Seattle Design Commission

MINUTES OF THE MEETING

04 August 2005

Interurban Exchange IV & V
Street Use Permit/Design Review
Transportation Projects
Pier 62/63 and Waterfront Park Feasibility Study

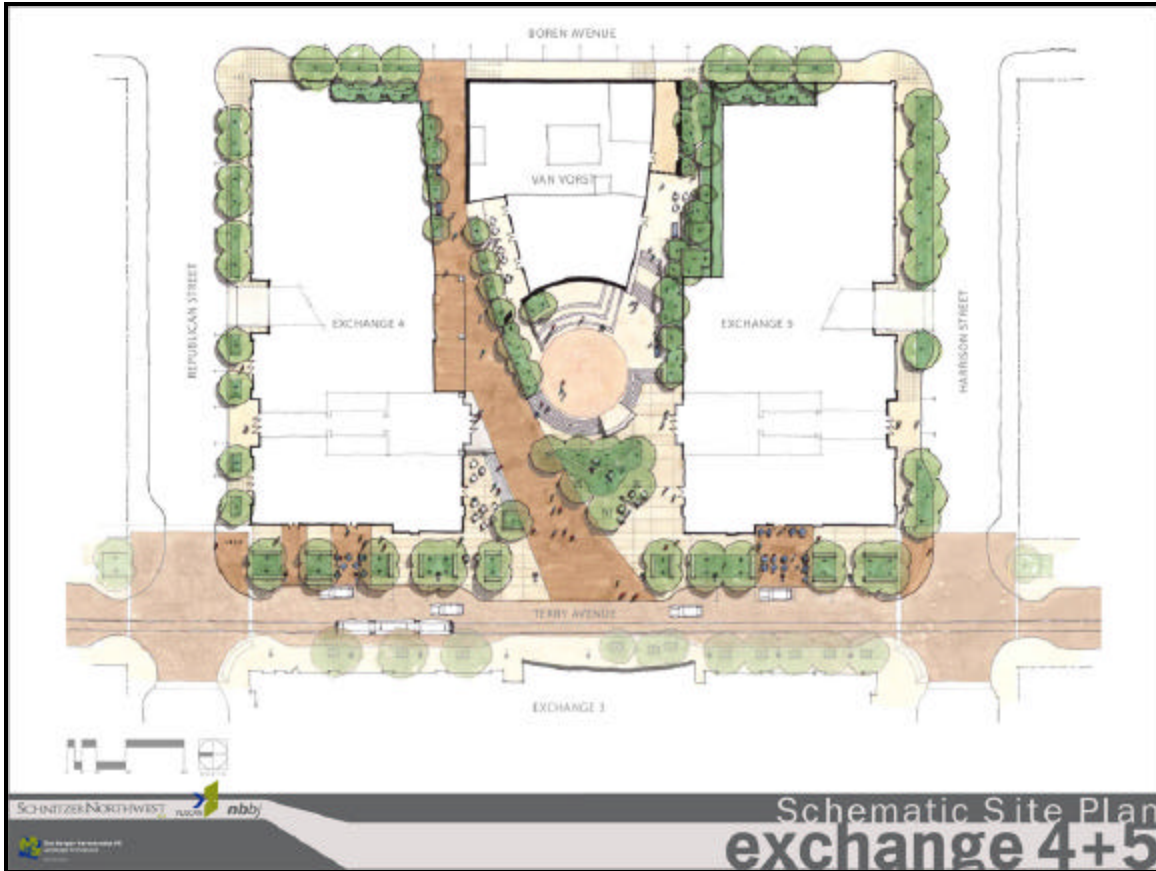
- Comments that the Van Vorst Building Addition is very different in its attitude towards the old building compared to the proponents past proposals, likes it, but wonders how others will respond
- Encourages the sculptural elements of the art piece, cautions proponents to make sure the art does not look merely like façade decoration, but rather stand as its own piece
- Likes the direction of the Van Vorst Building Addition and the focal point of art piece
- Asks if wind studies have been done for plaza

- The surrounding buildings are not tall enough to require study in the environmental impact study, does not believe it should be an issue
- Doesn't like the change in shape of Van Vorst Building Addition, liked the rectangular shape previously proposed

- Appreciates the simplification of the paving materials and planting design
- Feels that the proponents did not gain by removing the water feature
- Thinks that the central gathering space is extremely large for the daily use of the plaza and it could use a center feature to attract people into the space, if not water feature, perhaps put the art piece in the center of the plaza

- Comments that the trees shown in the proponents' renderings don't represent the proposed trees; suggested that proponents more accurately represent the size and nature of the trees proposed

- Suggests simplifying the stairway up to the art piece, making both sides mirror one another
- Appreciates the diagonal path and the architecture response to the gesture

- Appreciates the opening of the pinch points on either side of Van Vorst Building
- Suggests that the proponents use crushed stone below the bosque of trees instead of a ground cover, and maybe add a water element in bosque of trees

- Questions the location of the two trees at the base of the art wall, they seem awkward, suggests that they go down the stairs instead of along the wall

- The rendering intended to just show the planting spaces not the specific trees
- suggests that proponents consider Big Leaf Maple cultivar 'Seattle Sentinel' rather than the big leaf maples, they are smaller and have more vase-like shape, better for tight area

Concept Alternative #2: Market Street

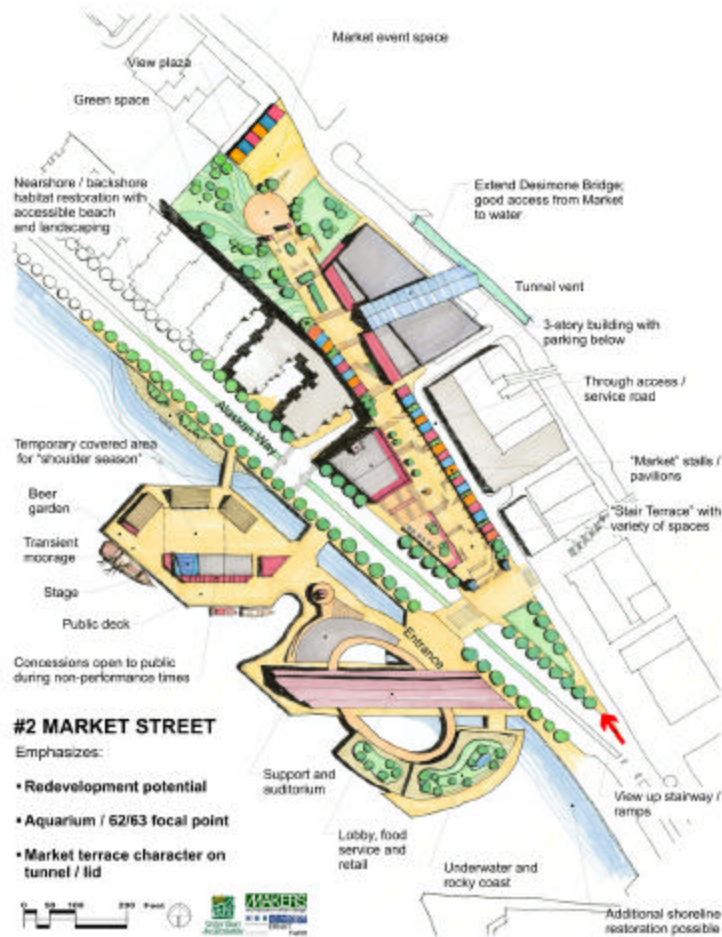
- Asks if there is better habitat in near shore conditions or with existing piers
- Feels that the study alternatives look like designs and feels it is too early in the design process to reach this level of specificity

- Believes that the proponents have gotten way too specific on the designs and suggests they go back to bubble diagrams, and feasibility of programming

- Asks proponents to rethink the big over water development space, and if it is needed, concentrate on multipurpose program use or general pedestrian use
